# Product Change Notice

Date:	September 17, 2019
Overview:	A change has been made to the terminal box for 94 frame AC motors
Reason for Change:	Improved design due to updated tooling
Affected Part No(s):	Ø400 mm radial fans and Ø400 to Ø500 mm axial fans using an AC motor (1-phase / 3-phase) in size 94 (exact PNs listed on last page of this notice)
Design Change Detail:	The new terminal boxes are more robust and have an improved sealing system - the bottom part of the terminal box now has integrated sealing which eliminates the need for an O-ring. The overall height of the terminal box remains the same.
Effective Date:	Running change, effective immediately
Last Time Buy Deadline:	N/A
Pricing:	No change
ebm-papst employee:	Jeannine Zenobi
Attachments:	<ul style="list-style-type: none"> <li>Detailed comparisons, original vs new design</li> <li>List of specific PNs affected by this change</li> </ul> 
Comments:	110 and 138 frame motors are also impacted (please see separate PCNs)

## AC Motor Size 94

## Measurements

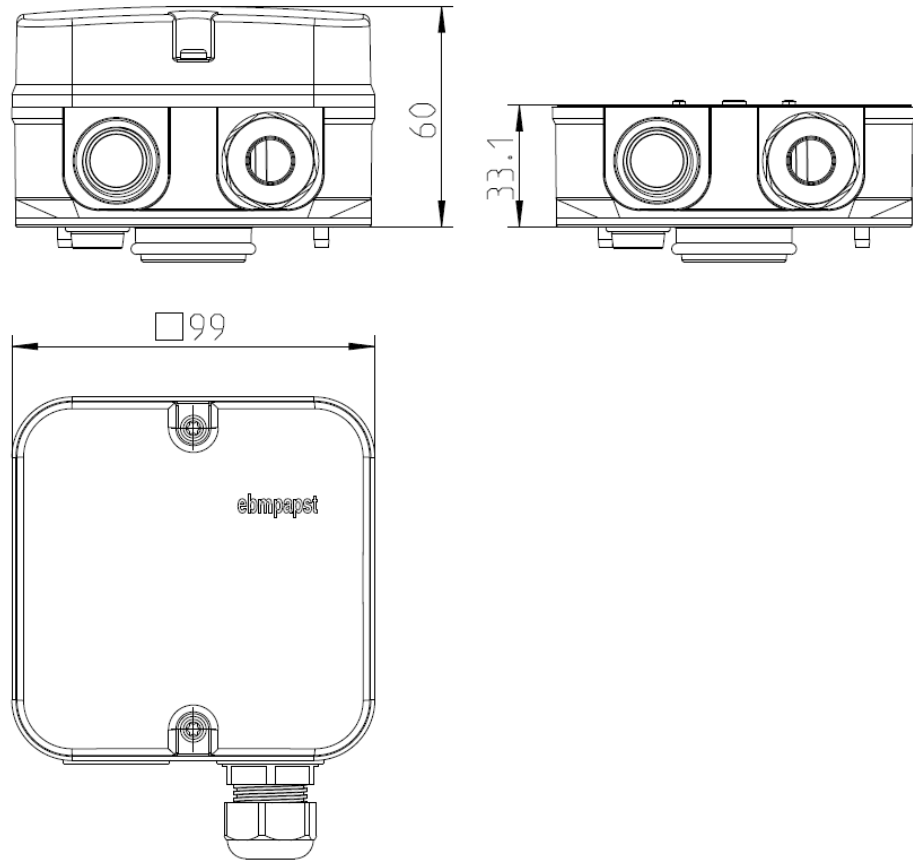
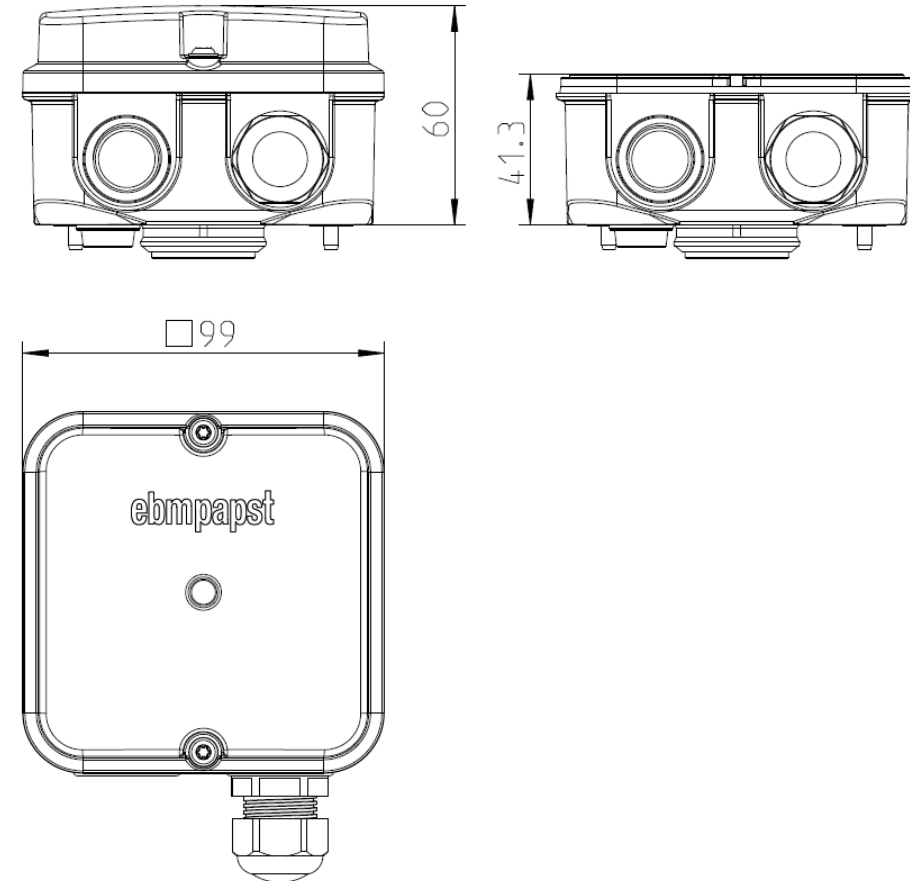
Original Terminal Box

New Terminal Box

Improved sealing system

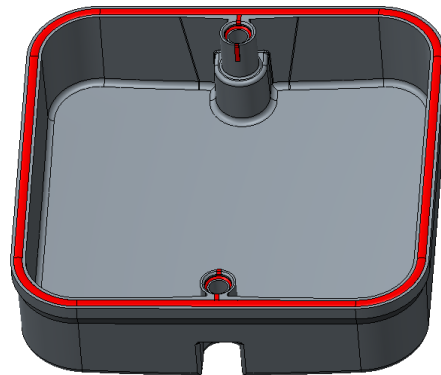
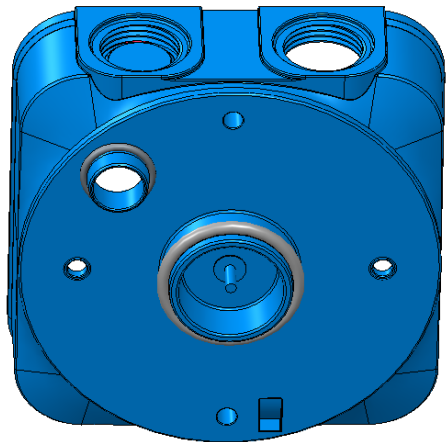
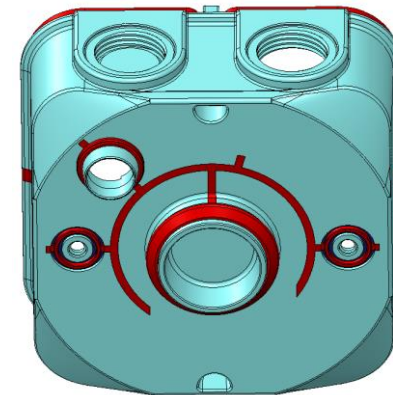
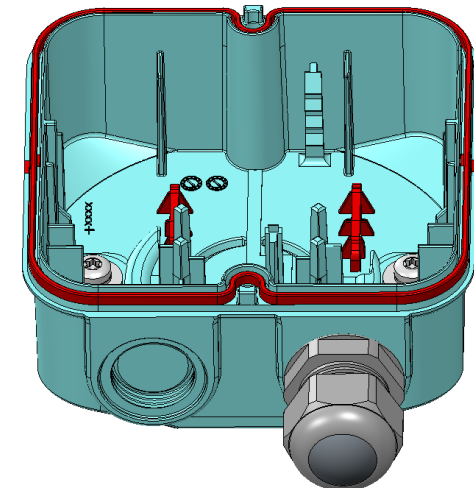
O-rings

Sealing in terminal box  
(cover)

2K-sealing  
(similar to sizes 110 and 138)

Improved sealing  
(bottom)

Capacitor fixation inside bottom of terminal box (1~ fans)

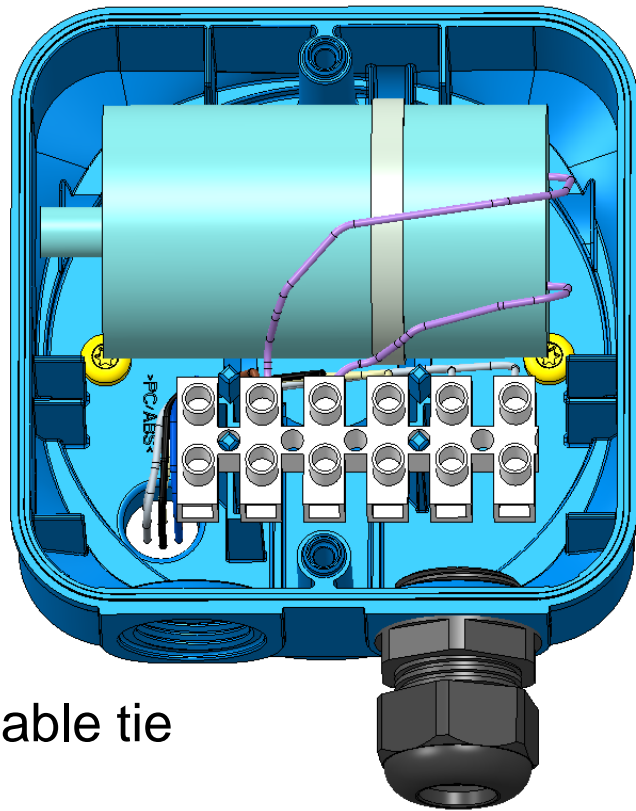
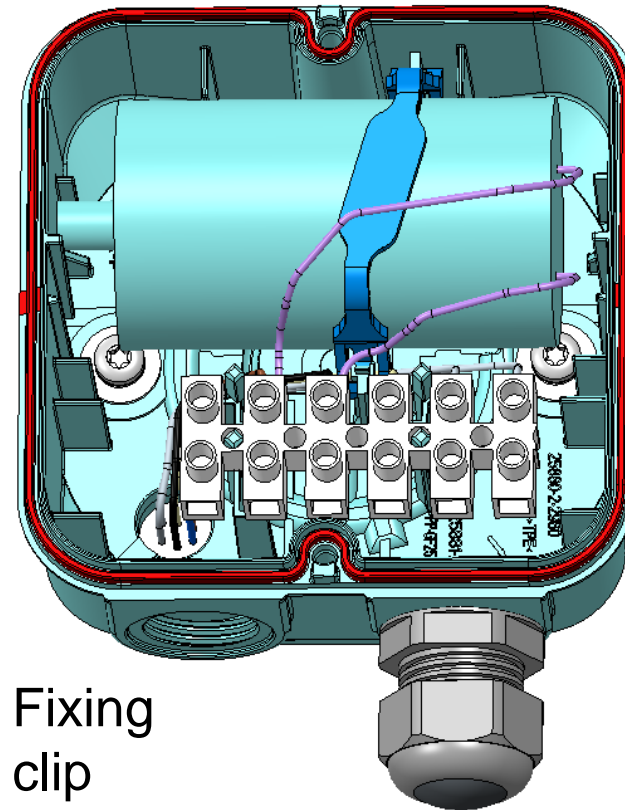
Cable tie

Fixing clip
